**New York City Department of Transportation  
Division of Bridges  
Bureau of Specialty Engineering and Construction  
Design Build/Emergency Contracts Unit**

**DESIGN, CONSTRUCTION AND CONSTRUCTION SUPPORT SERVICES  
FOR THE REHABILITATION OF  
THE ST. GEORGE STATEN ISLAND FERRY TERMINAL RAMPS  
BOROUGH OF STATEN ISLAND  
CONTRACT No. HBR1217  
P.I.N. 84106SIBR096**

**Addendum # 4**

**December 21, 2007**

**PIGEON DETERRENT SYSTEM  
LIMITS OF WORK**

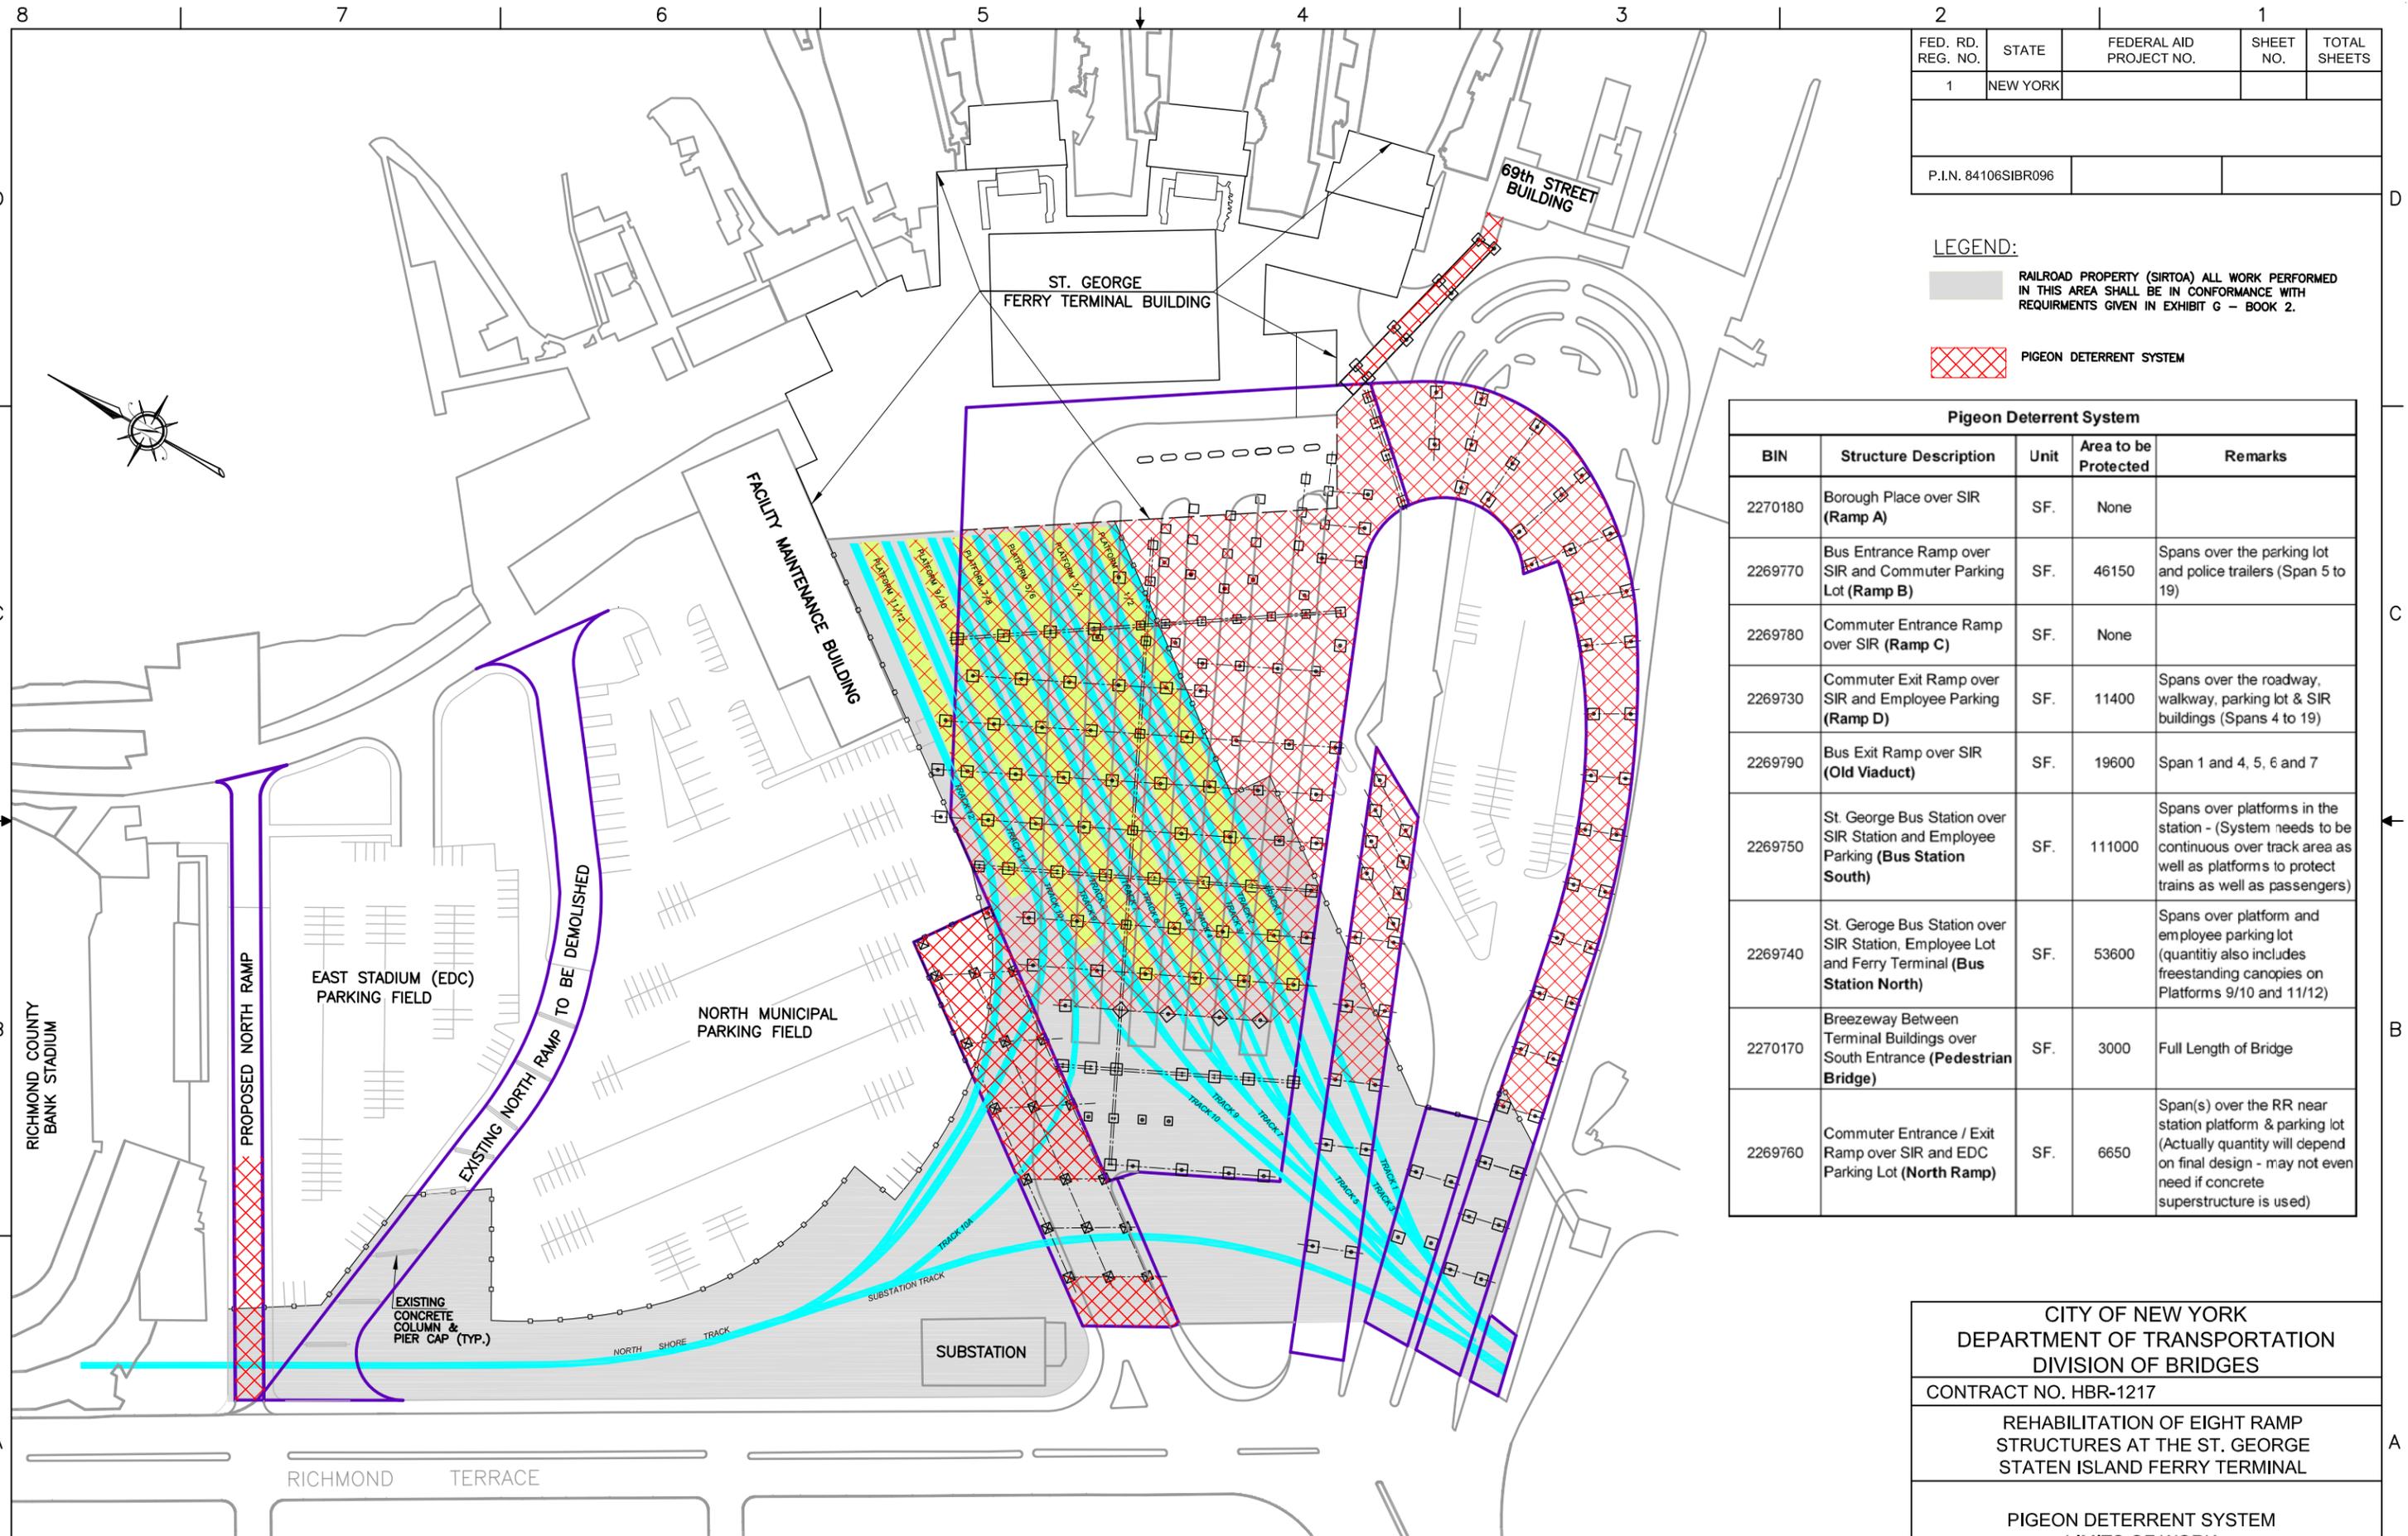
- A15: The Preliminary Quantities Estimate given in Section 4 of Exhibit E in Book 2: Volume 2 gives the SF area of where the pigeon deterrent system is required. Attached to this Addendum No. 4 is a plan view of the project site depicting the areas requiring the pigeon deterrent system. Only an electrified wire pigeon deterrent system will be acceptable to the NYC DOT.**
